**Addendum 1**

**Bid No. 24-048**

**Asphalt and Concrete Repair**

**Annual Contract**

PW-02

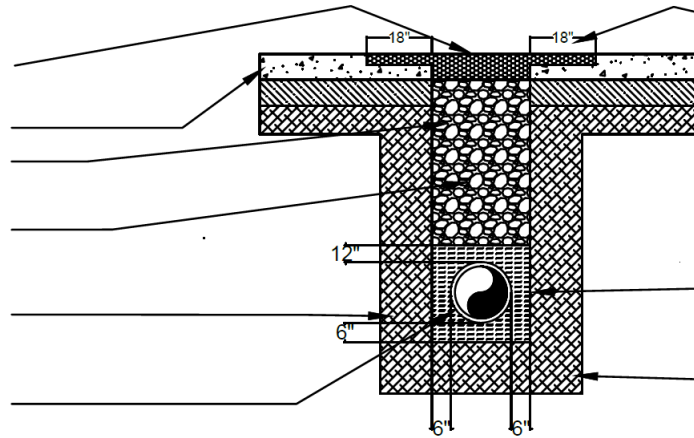
2. See attached REVISED Right-of-Way Repair Detail Plan.

CORE IS TO BE REPAIRED TO FULL DEPTH OF CONCRETE OR ASPHALT WITH HIGH STRENGTH NON-SHRINK GROUT.

POTHOLE TO BE BACKFILLED WITH FLOWABLE FILL MEETING CLSM STANDARD (50 PSI BREAK) SEE FLOWABLE FILL MIX DESIGN BELOW

ASPHALT PATCH TO BE MINIMUM 1.5" DEPTH AND MILLED TO 1" DEPTH AND 18" WIDTH ON ALL SIDES OF PATCH TO MATCH EXISTING THICKNESS WITH HOT MIX ASPHALT (424A WEAR SURFACE). INNER SURFACE TO BE TACKED.

EXISTING SUBGRADE MUST BE REPLACED WITH ALDOT 825 TYPE B BASE OR EQUIVALENT. SCARIFY 2LB SQ-FT OF PORTLAND CEMENT INTO SUB GRADE PRIOR TO ASPHALT PLACEMENT.

UTILITY TO BE BEDDED 6" BELOW, 6" BOTH SIDES AND 12" ABOVE.
